Village of Bronxville Site Development Application

Application Review - ALT 048-21 25 Sagamore Road Driveway reconfiguration Plans dated as received 3/16/21

As requested, we have reviewed a Site Development Application form dated 5/8/21; Part 1 of a Short Environmental Assessment Form (EAF) dated 4/23/21; and a set of plans generally entitled, "Gramatan Court Parking Lot Renovation," prepared by Peter Gisolfi Associates, LLP, dated 4/30/21.

GRAMATAN COURT PARKING LOT RENOVATION

AASHTO SIGHT LINE FIGURE

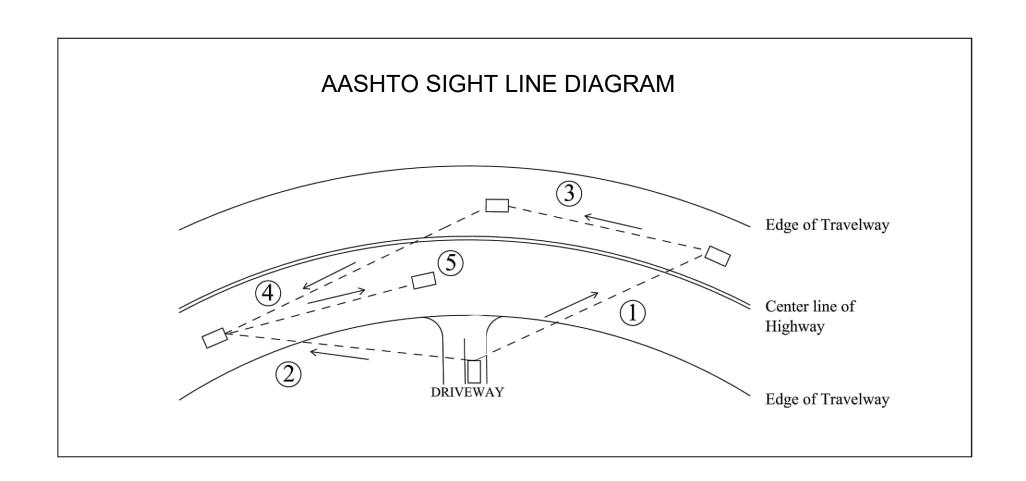
The attached Figure illustrates the five sight lines investigated at each driveway. When measuring the Stopping Sight Distance, the elevation for a driver's eye height is recommended to be 3.5 feet and they should be able see an object in the Kensington Road at the same elevation. AASHTO indicates that almost all U.S. passenger vehicle distances from front end of vehicle to driver's eye is 8 feet. Therefore, the proposed sight line measurements can be performed at 8 feet setback along the driveway from the edge of travelway on Kensington Road. The following Table provides a summary of the measured Stopping Sight Distances at each driveway location:

As can be seen in the Table above all measured Sight Distances will exceed the minimum Stopping Sight Distance for 30 MPH (200 feet). Any vegetation planted in the sight lines will need to be low profile or low caliper/high canopy to not obstruct the necessary sight lines.

Based on the foregoing, it is the professional opinion of Provident Design Engineering that the proposed driveway locations will adequately provide the necessary sight lines to meet the minimum Stopping Sight Distance for a 30 MPH design speed in accordance with AASHTO criteria. Should you wish to discuss any aspect of this letter, please feel free to contact me at 914.367.0204 or via email at cholt@pderesults.com.
